Access Compliance Report

Public Rights-of-Way

(Curb Ramps)

Intersection ID: 28130	Main Street: PORTMARNOCK_CT	Cross Street: TOM_SHORT_RD	Location: NW
ADA ID: 723129BFAF95	Ramp Type: PerpDiag	Initial Pass/Fail: Fail	Overall Compliance: No
Severity Score: 48.75			
Codes/Mitigation Info/Possible Solution		Field Measurements/Component Compliance

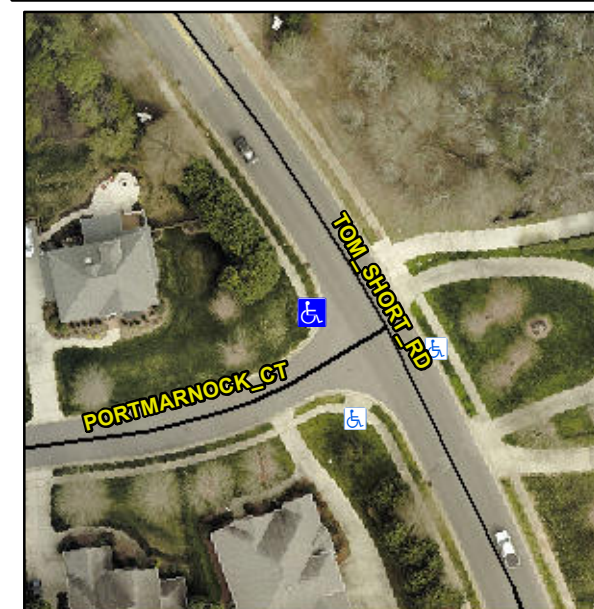
R304.5.1, R304.2.2, R304.5.3

Compliance	Description	Data	Compliance	Description	Data
N/A	Ramp Length (in)	120.0	No	Ramp Slope (%)	8.5
No	Ramp Width (in)	29.0	No	Ramp XSlope (%)	4.7
N/A	Flare Type LT	N/A	N/A	Flare Type RT	N/A
N/A	Flare Slope LT (%)	N/A	N/A	Flare Slope RT (%)	N/A
N/A	Flare Traversable LT?	N/A	N/A	Flare Traversable RT?	N/A
N/A	Landing Length (in)	N/A	N/A	DWS Provided?	N/A
N/A	Landing Width (in)	N/A	N/A	DWS Contrast?	N/A
N/A	Landing Slope (%)	N/A	N/A	DWS Length (in)	N/A
N/A	Landing X Slope (%)	N/A	N/A	DWS Full Width?	N/A
N/A	Landing Curb? (Y/N)	N/A	N/A	DWS Offset (in)	N/A
N/A	Shared Landing?	N/A			
N/A	Gutter Ponding?	N/A	N/A	Gutter Slope (%)	N/A
N/A	Gutter Lip Ht (in)	N/A	N/A	Gutter X Slope (%)	N/A
N/A	Painted X Walk1?	No	N/A	Painted X Walk2?	No
	X Walk 1 Direction	To SE		X Walk 2 Direction	To NE
N/A	X Walk 1 Width (in)	N/A	N/A	X Walk 2 Width (in)	N/A
	X Walk 1 Slope (%)	0.9		X Walk 2 Slope (%)	4.2
	X Walk 1 X Slope (%)	3.3		X Walk 2 X Slope (%)	0.4

N/A	Ramp inside XWalk1?	N/A	N/A	Ramp inside XWalk2?	N/A
	Road Slope (%)	2.8	N/A	Clear Space?	N/A
	Road X Slope (%)	4.4	N/A	Clear Space to XWalk (in)	N/A
N/A	Any Obstructions?	N/A	N/A	Storm Grate/Utility Hazard?	N/A
	Obstruction Type			Storm Grate/Utility Type	
		N/A			N/A
			Yes	Surface Condition? (G/P)	Good

Remove & Replace Curb Ramp With Two New Directional Ramps or Equivalent.
